Submittal Review

Project Name: Chipotle Mesa, AZ
Project Number: 22.013
Date Received: 09/22/2022
Description: CaptiveAire Kitchen Hood/MAU/EF submittal

CHIPOTLE EASTMARK #4189
MESA, AZ, 85212

- FAN #3 AI-D250-15D - HEATER (MAU-1)
1. DIRECT GAS FIRED HEATED MAKE UP AIR UNIT WITH 15' MIXED FLOW DIRECT DRIVE FAN.
 2. INTAKE HOOD WITH EZ FILTERS.
 3. DOWN DISCHARGE - AIR FLOW RIGHT -> LEFT.

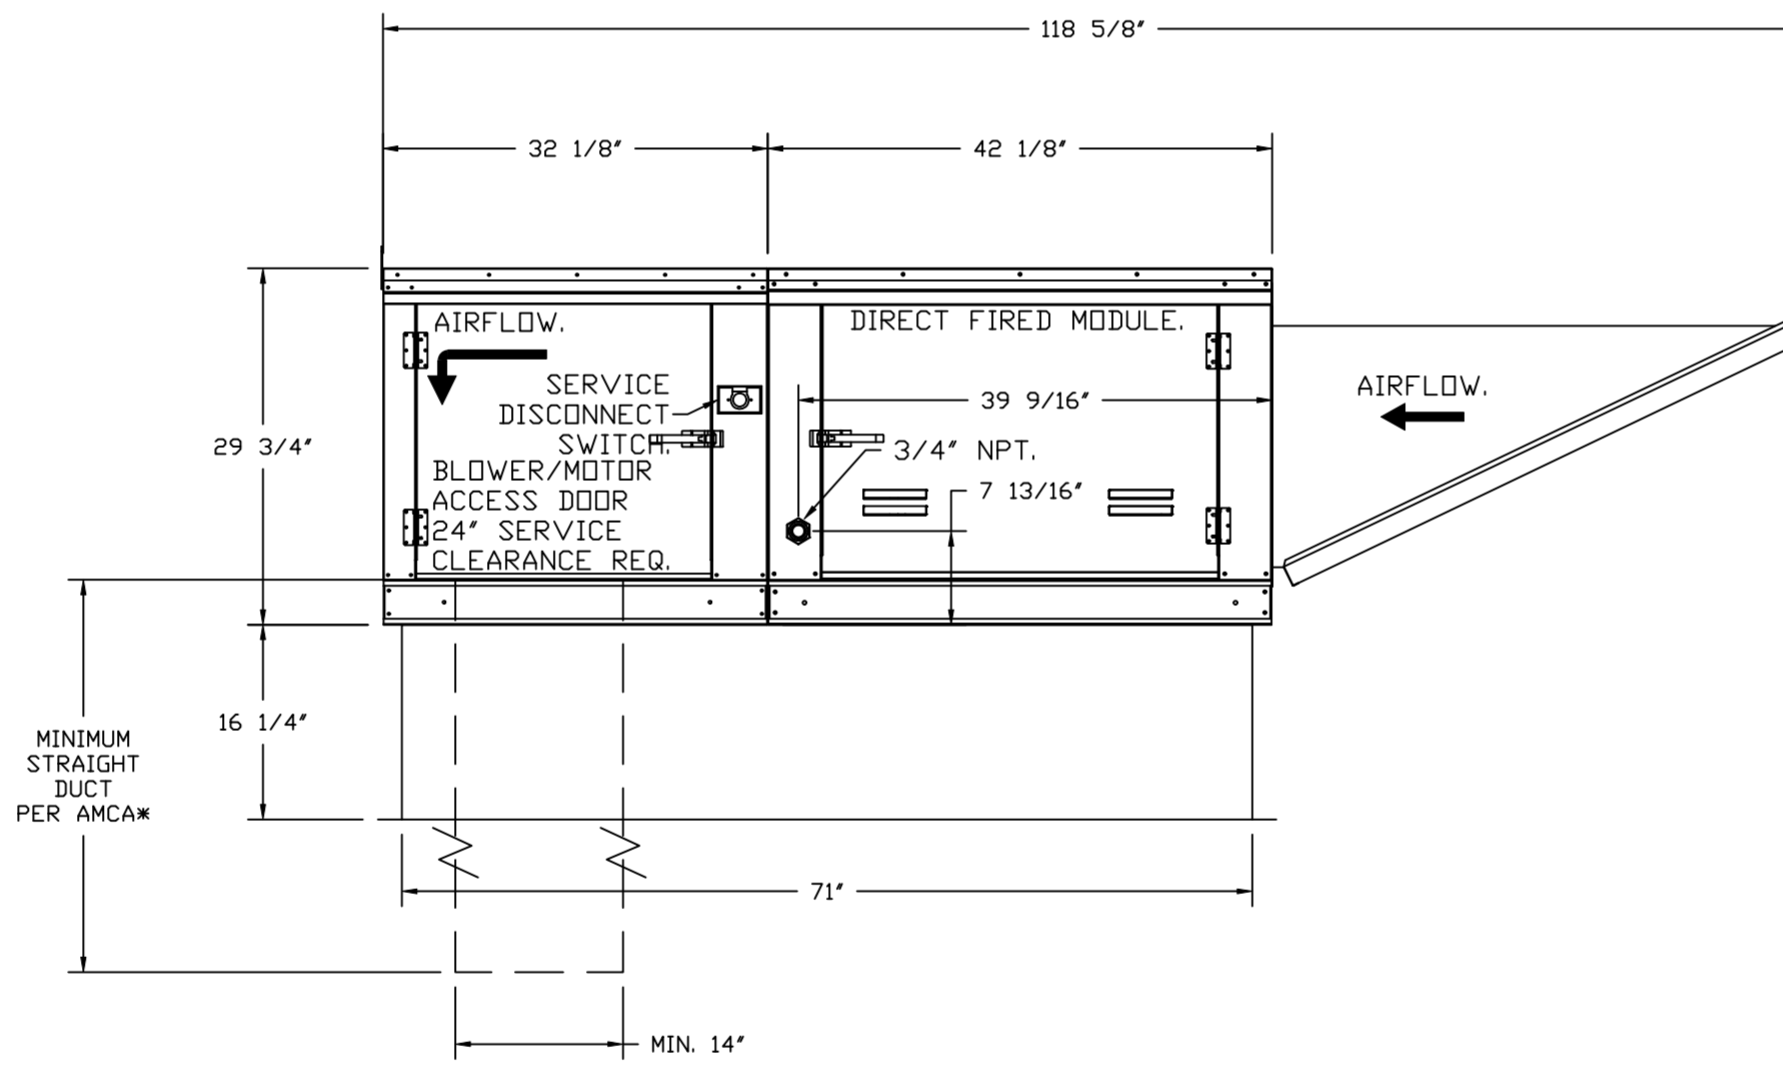
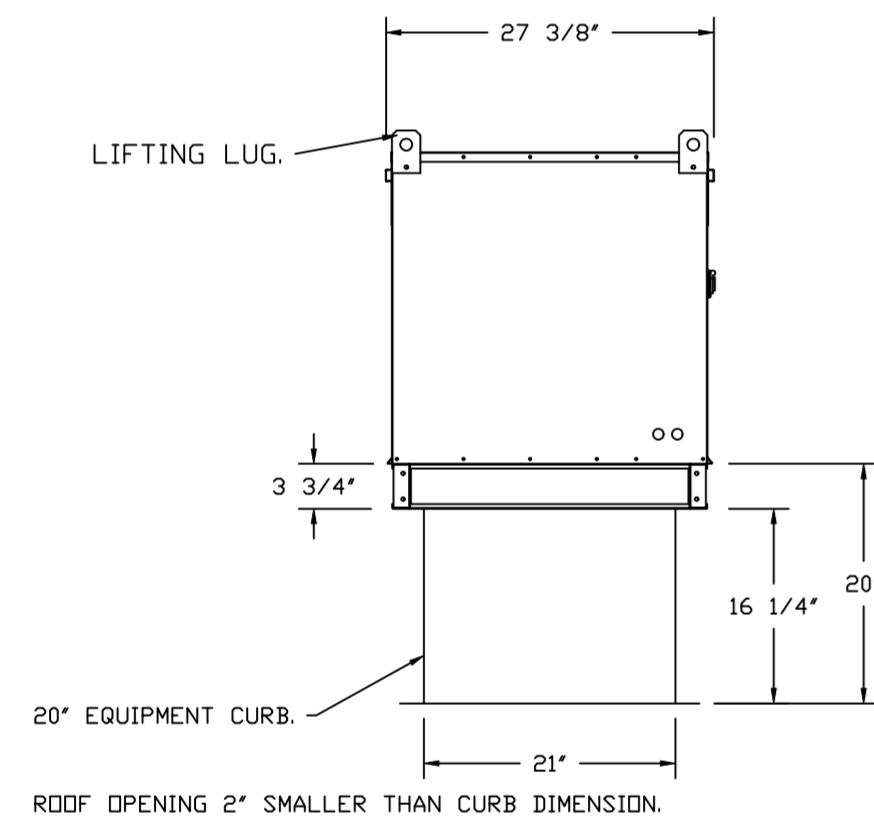
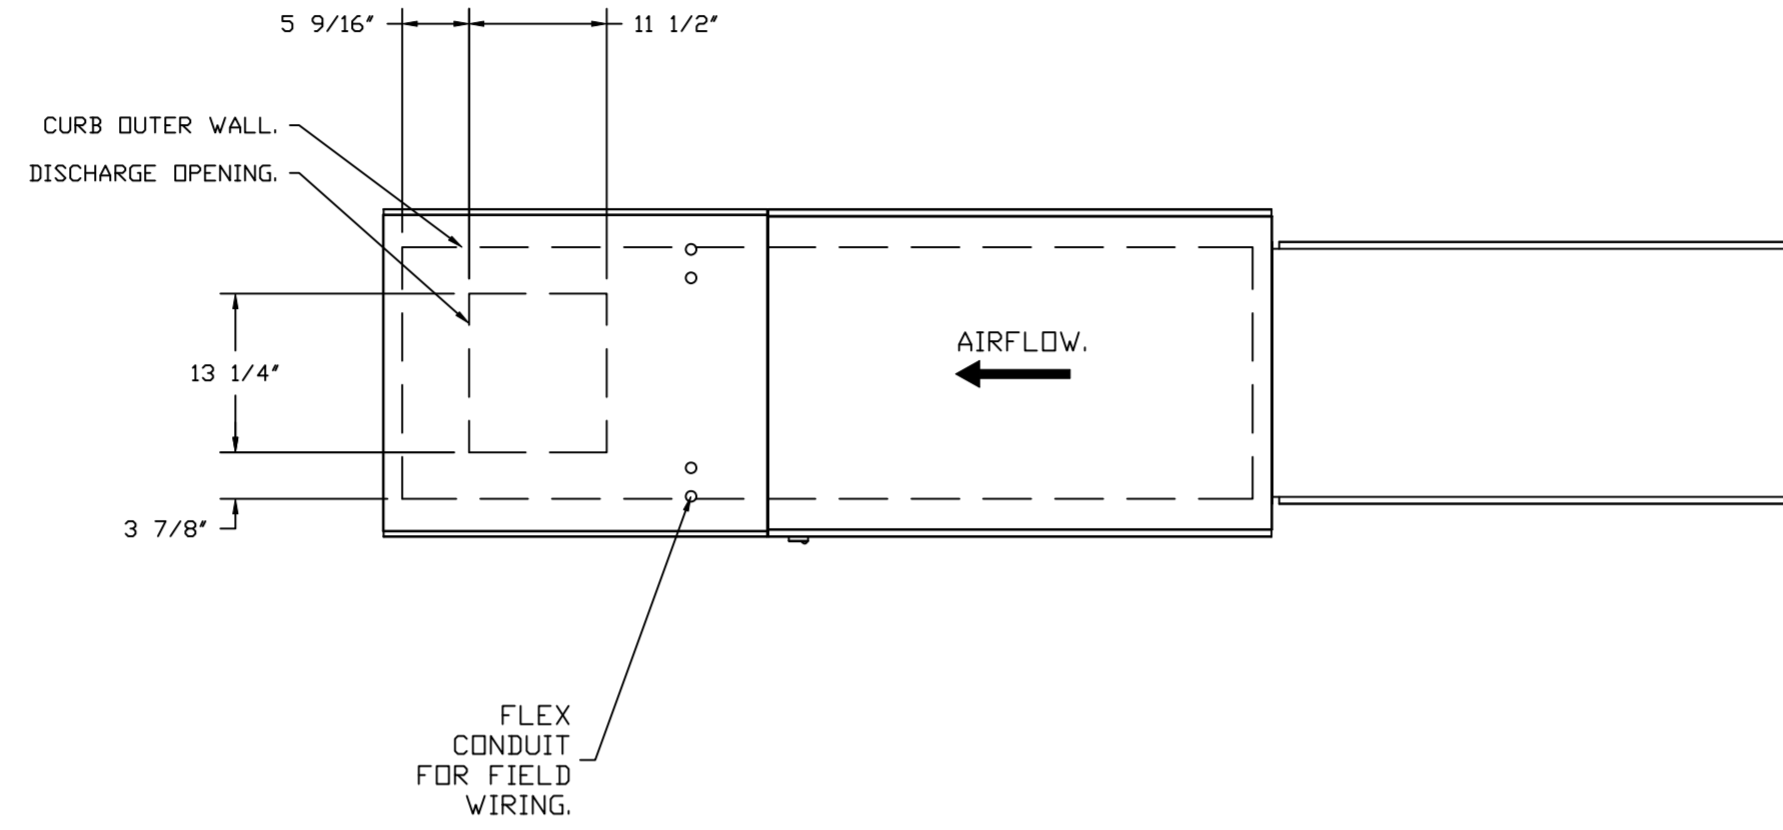
1. HD-1: CAPTIVEAIRE 5424 ND-2-ACPSP-F – **NO EXCEPTIONS TAKEN**
 - Provide with all accessories as listed on plans.
2. MAU-1: CAPTIVEAIRE A1-D.250-15D – **NO EXCEPTIONS TAKEN**
 - Provide with all accessories as listed on plans.
 - Note that natural gas input/output on submittals differs from that shown on mechanical plans. However, the input/output shown on submittals will provide appropriate heating per code. No exceptions taken.
3. EF-1: CAPTIVEAIRE DU240HFA – **NO EXCEPTIONS TAKEN**
 - Provide with all accessories as listed on plans.
4. EF-2: CAPTIVEAIRE DR12HFA – **NO EXCEPTIONS TAKEN**
 - Provide with all accessories as listed on plans.
